## I shared "CMC Responses to DRMS AR NO. 3.docx" with you in OneDrive

### CMC Responses to DRMS AR NO. 3

I received your 10 emails sent Friday including an adequacy response letter and several maps for Gold Hill Mill AM-1. Do you intend to also submit a complete hard copy to our office?

Amy Eschberger: Attached to this email are CMC's Responses to some of the Adequacy Review questions that you included in your letter dated January 14, 2019. I will be sending additional responses to you during the next few days.

E-1 MINE PLAN - COLORADO MILLING CO.-GOLD HILL MILL WATERLINE  
LOCATED IN SECTIONS 2/11/12, T-1-N, R-72-W OF THE SIXTH P.M.,  
COUNTY OF BOULDER, STATE OF COLORADO

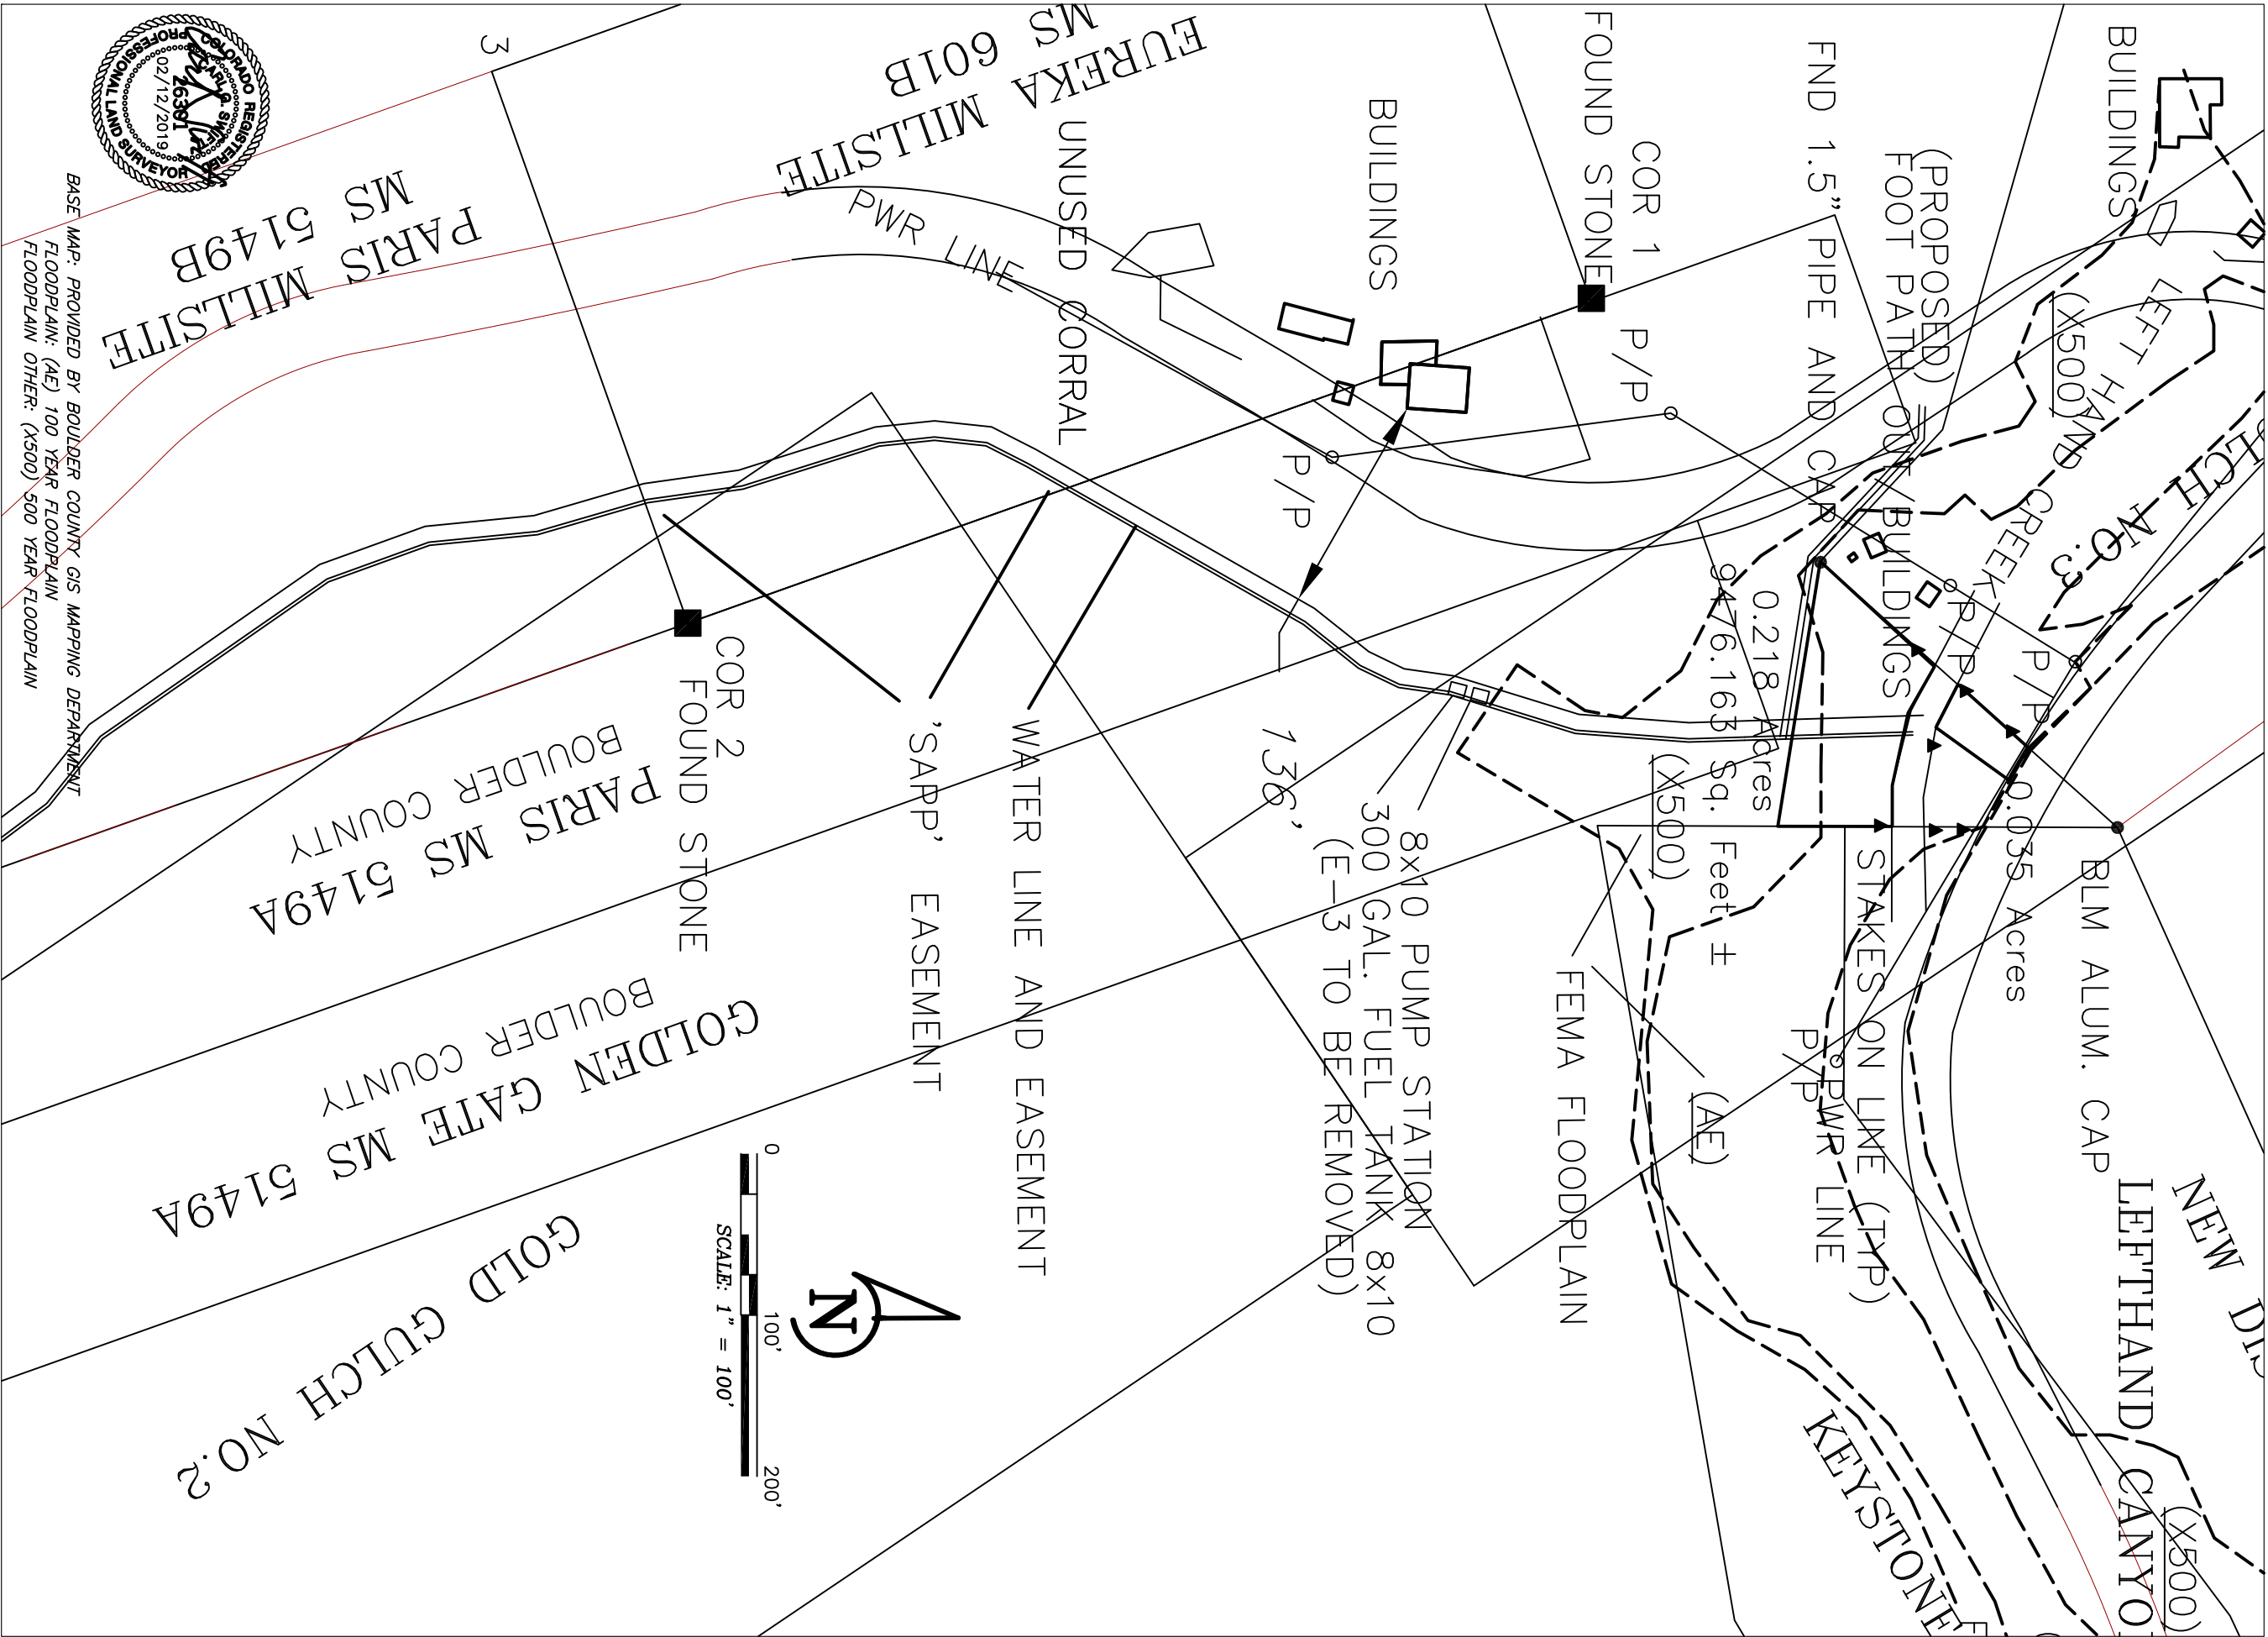
1) The operator's response to item no. 8 states the footbridge will no longer be installed, and that a field survey has disclosed a gap between the Mammoth MS No. 17576 and the Paris MS No. 5149A that will provide access to the pump station from Lickskillet Road. This open area is located entirely on the Gold Gulch unpatented lode mining claim owned by the operator. Please describe this new proposed access to the pump station. Is there an existing trail/road in this area? If so, will it need to be improved and/or widened for access by the operation? Will any vegetation need to be removed from this area? This information is needed for the Division to determine whether the access is considered affected land pursuant to Rule 1.1(4). Please show this proposed access on the E-1 – Mine Plan Map.

3) The operator's response to item no. 10 states the operation will access the water pipeline easement using four historic mine roads. Please describe these existing roads. Will the roads need to be improved and/or widened for use by the operation? Will any vegetation need to be removed from these areas? This information is needed for the Division to determine whether the access roads are considered affected land pursuant to Rule 1.1(4). Please show these historic mine roads on the E-1 through E-5 maps.

**CMC Response:** This lowermost access to the Gold Hill Mill Waterline will be a three (3) foot wide foot path between Lickskillet Road and the area below the location of the Pump Station. It will be located entirely on the Gold Gulch No. 3 unpatented lode mining claim. This foot path will be approximately two-hundred and fifty (250) feet long. The foot path will be located on a grassy slope for a distance of approximately one-hundred and twenty-five (125) feet, until it reaches the Southeast corner of the Mammoth Millsite, MS No. 17576, where the land flattens in the Left Hand Creek flood plain. Aside from this grassy slope, most of the foot path will be situated on sand and gravel deposited in this area by the fluvial activity of Left Hand Creek. The use of this foot path will not require the removal of any large pine trees or significant vegetation along the course of this access path to the lower end of the Gold Hill Mill Waterline. Most of the larger species of vegetation in this area consists of small deciduous trees such as Quaking Aspen, Narrow Leaf Cottonwood, Mountain Alder, and Rocky Mountain Maple trees. Some of these may have to be cut back to provide access to the lower segments of the Waterline, but it is not expected that any large trees will have to be removed for this purpose.

**CMC Response:** The Gold Hill Mill Waterline will be accessed using four historic mine roads. The main access road to the Gold Hill Mill Pipeline Easement is located off of Lickskillet Road on the Paris Millsite, MS No. 5149B. This first access road connects with the historic mine road from Left Hand Canyon to Gold Hill. It provides access to the Pipeline Easement in both directions towards Left Hand Creek to the North, and as far as the Cold Spring No. 2 Lode Claim to the South. The second historic mine access road to the Pipeline Easement extends from Lickskillet Road with two branches to the Red Cloud and Cold Spring Mines, which are located in this area. The third historic access road to the Pipeline Easement also extends from Lickskillet Road with two branches to the Alamakee Mine. The fourth historic access mine road extends from Sunshine Canyon Road to the portal of the Times Mine. All of these historic mine access roads are shown on the Surface Ownership & Permit Area Map E-2, the Mine Reclamation Plan Map E-3, the Surface Ownership & Permit Area Map E-4, and the Access-Water Line and Easements Map E-6.

E-3 MINE RECLAMATION PLAN  
COLORADO MILLING CO.- GOLD HILL MILL WATERLINE  
LOCATED IN SECTIONS 2/11/12, T-1-N, R-72-W OF THE SIXTH P.M.,  
COUNTY OF BOULDER, STATE OF COLORADO

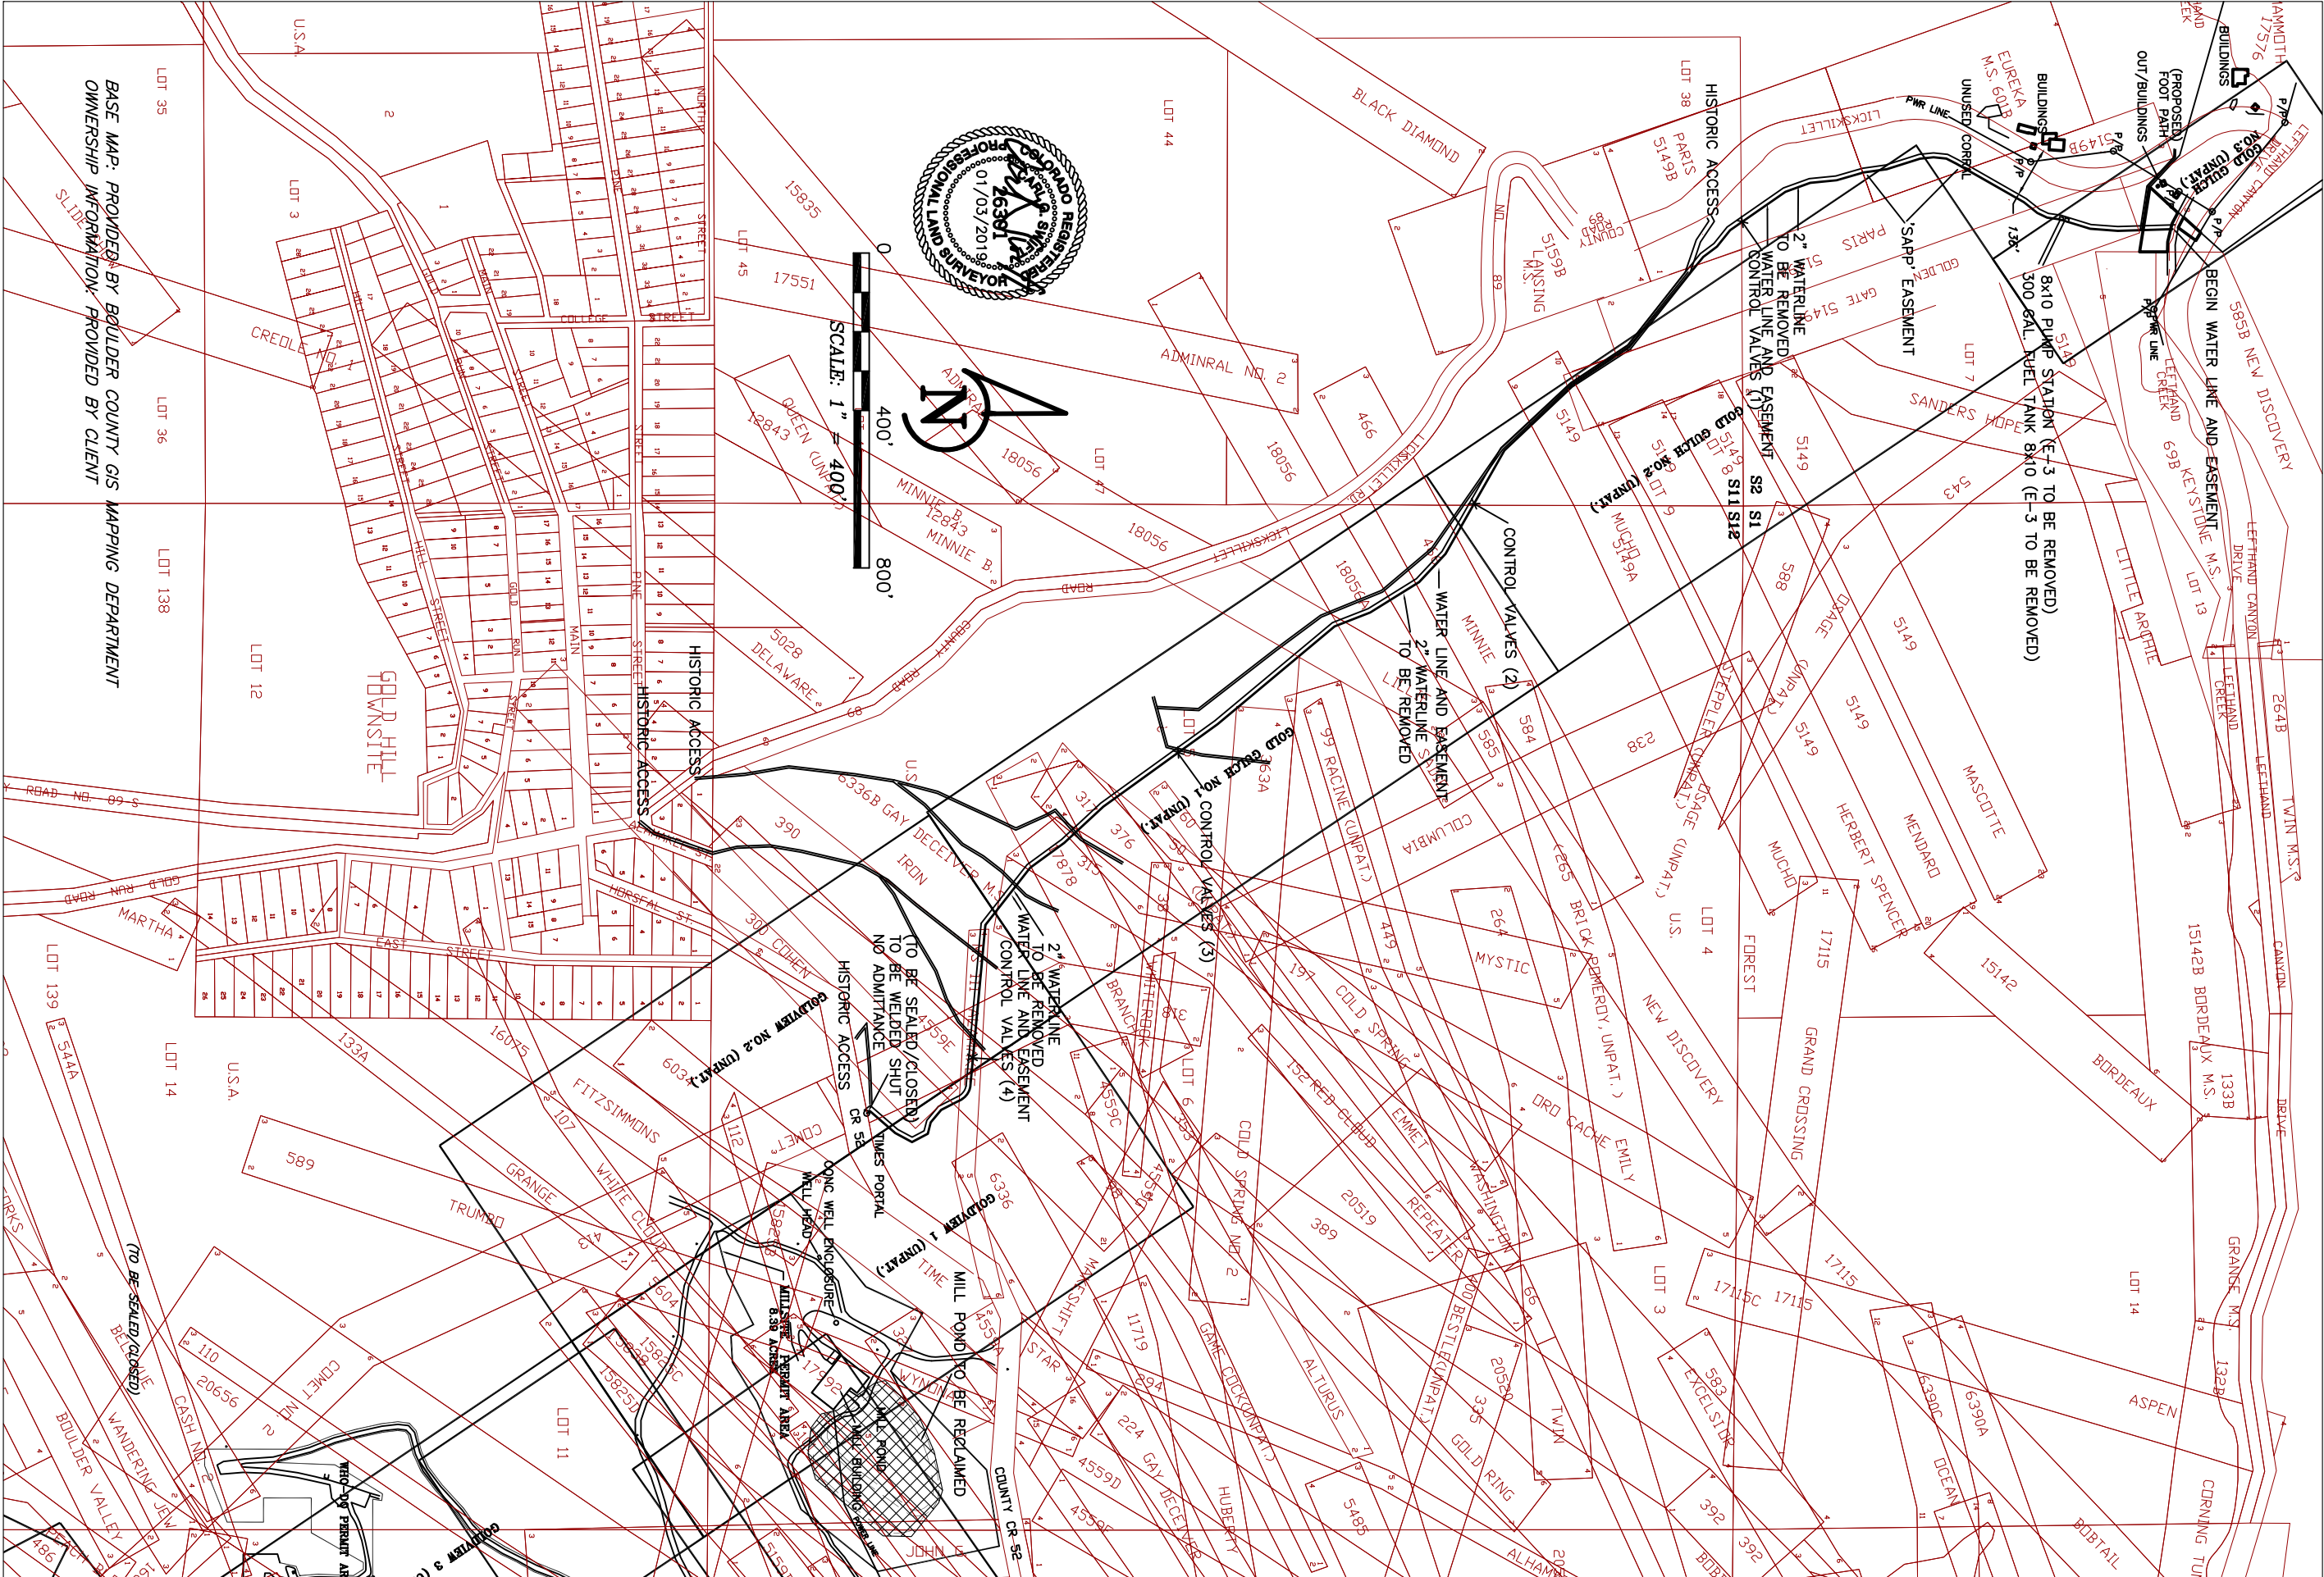
13) Please describe the proposed reclamation plan for the Wynona Mine shaft. Additionally, please be sure the closure costs for this shaft are included in the reclamation cost estimate.

**CMC Response:** The Wynona Mine shaft will not be reclaimed. Neither will the Times Mine drill hole site. Both of these drill holes will be used by the Gold Hill Mill as a future source of emergency water in case of another forest fire similar to the Four Mile Canyon Fire that devastated the South side of the property now owned by CMC. A diesel or gasoline powered generator will be installed to provide electrical power to both of these drill hole sites, and a sprinkler system will be placed around the Millsite. This fire control system is necessary, because another large forest fire in this area is probably inevitable given the tremendous overgrown on the North side of this property from Sunshine Canyon Drive to Left Hand Creek. In that event, the water in these two mines will be needed to protect the Gold Hill Millsite from another forest fire in this area. This will obviate the closure costs for closing the Wynona Mine shaft and reclaiming the drill hole into the Times Mine workings.
